Additions and Renovations
Platt Technical High School
Milford, CT

ADDENDUM NO. 3

August 2, 2019

1 FIRST FLOOR ELECTRICAL SYSTEMS PLAN AREA A
1/8" = 1'-0"

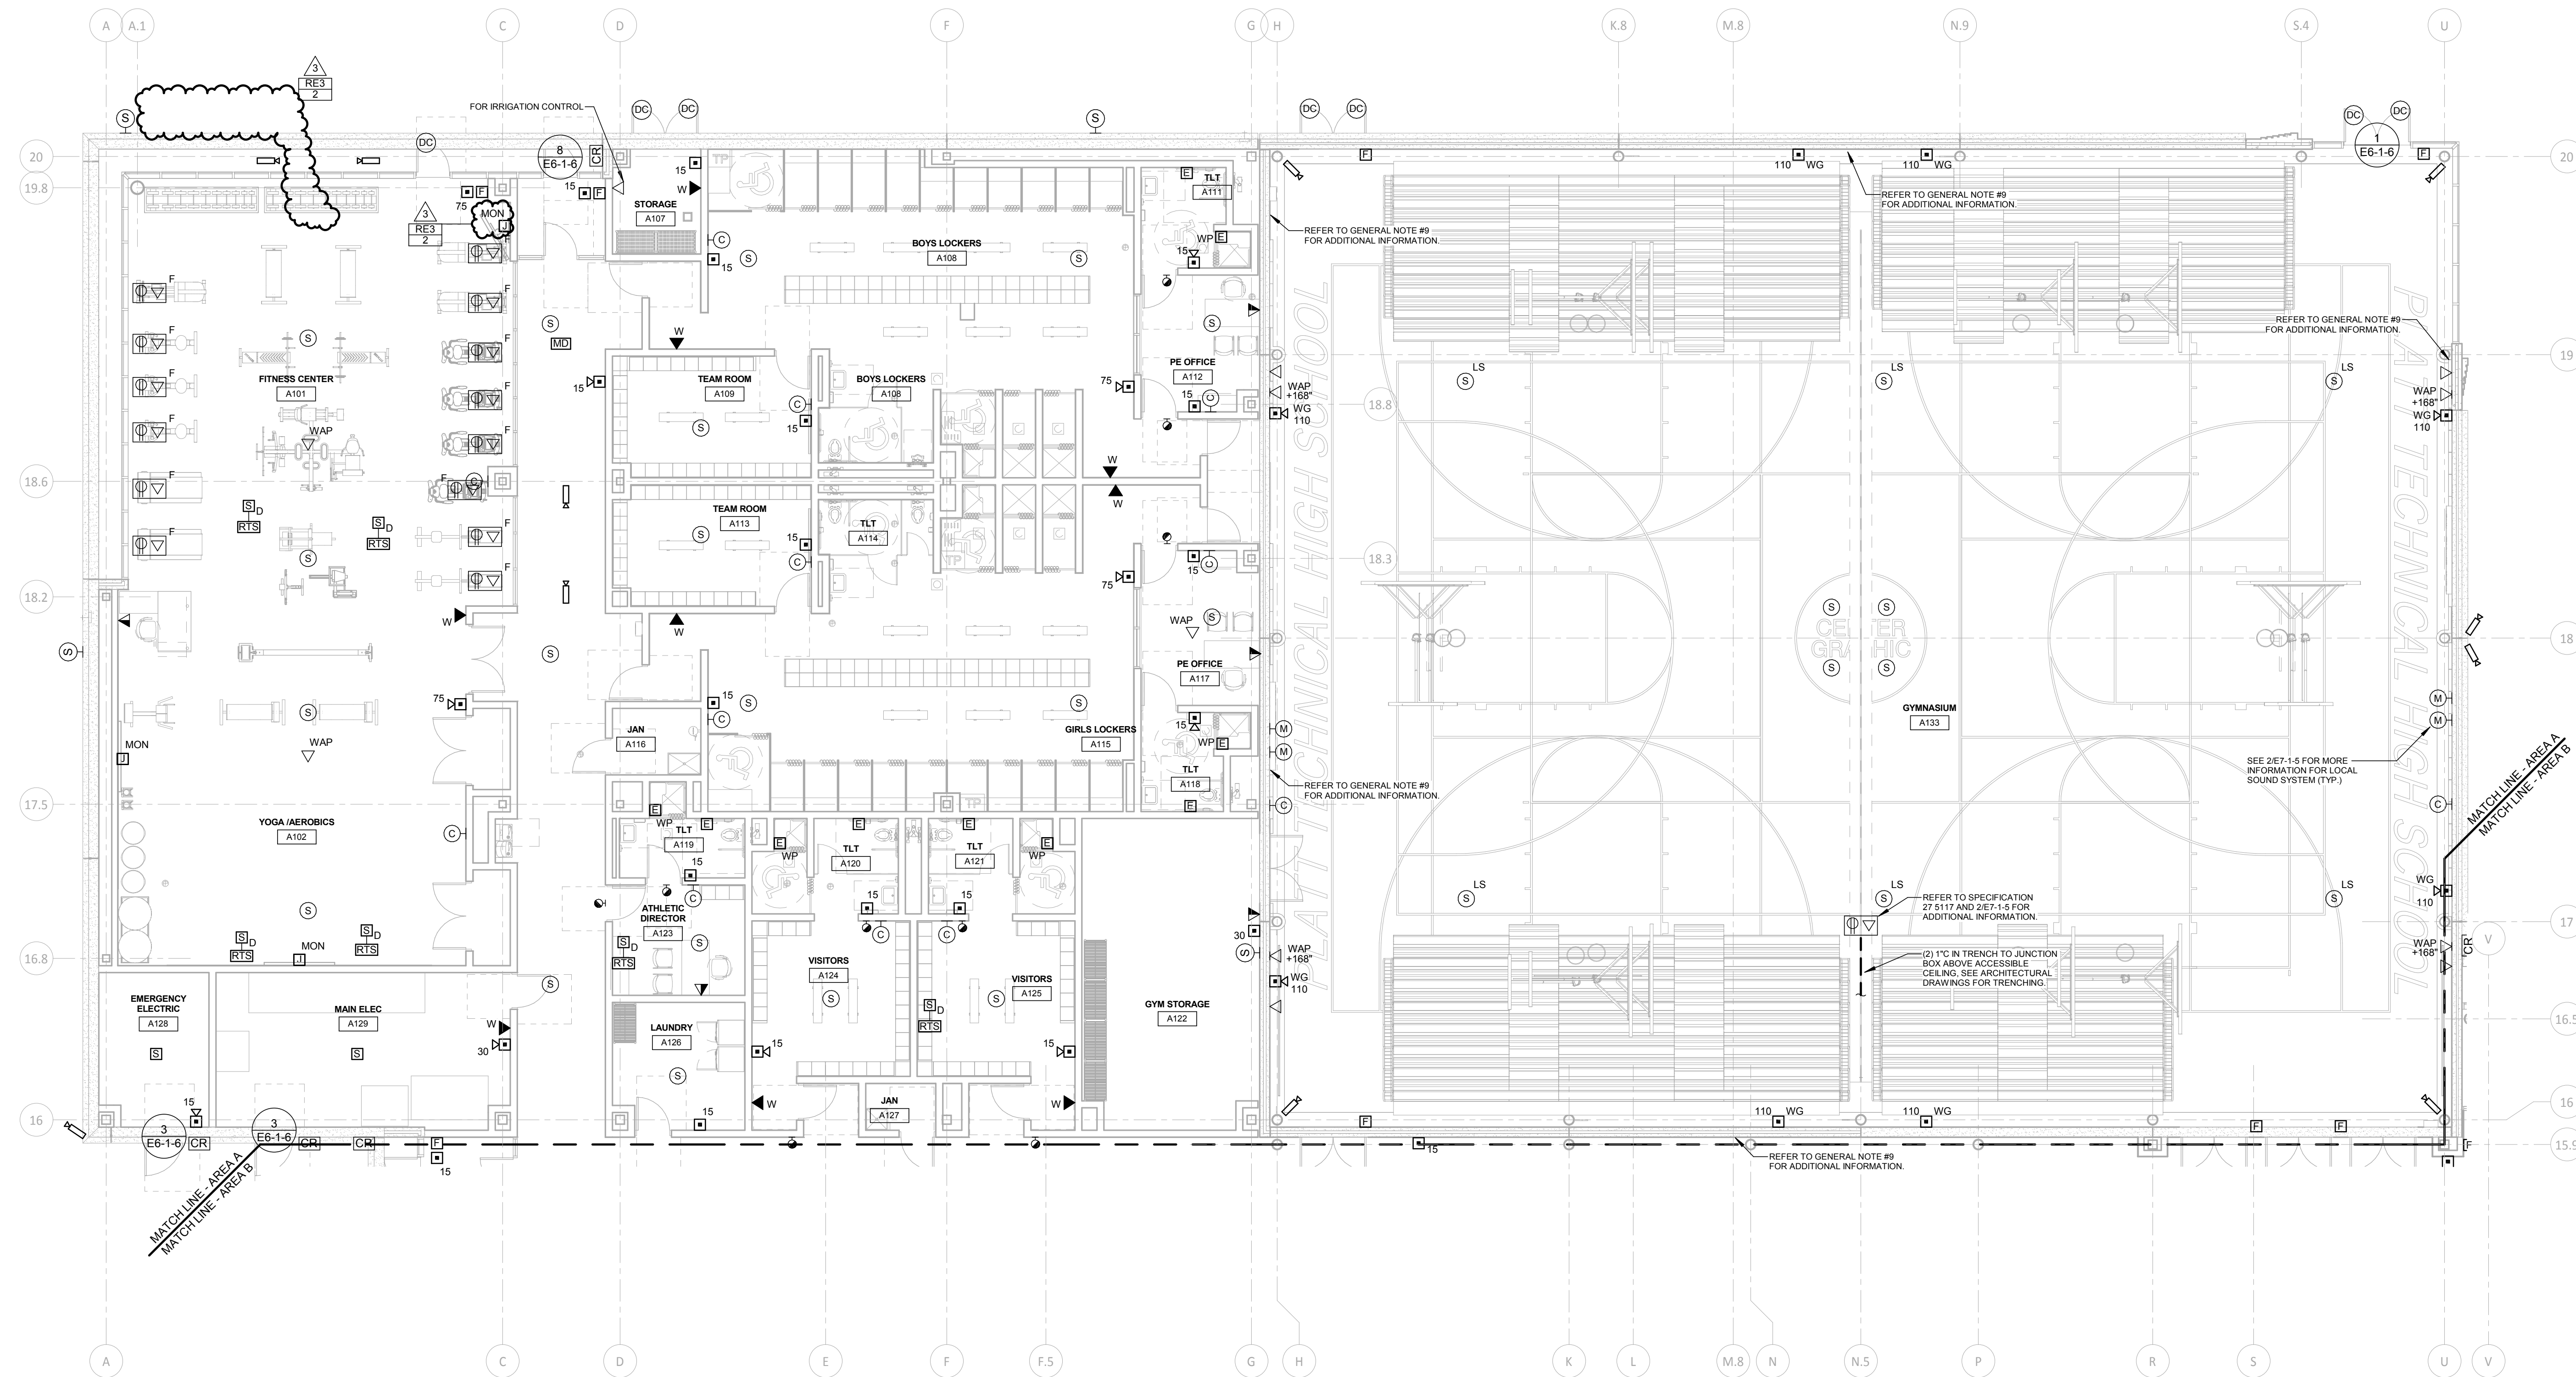
ADD 3-083 DRAWING E3-1-1A – FIRST FLOOR ELECTRICAL SYSTEMS PLAN AREA A
Relocated ceiling mounted junction box for monitor per Revision RE3-2.
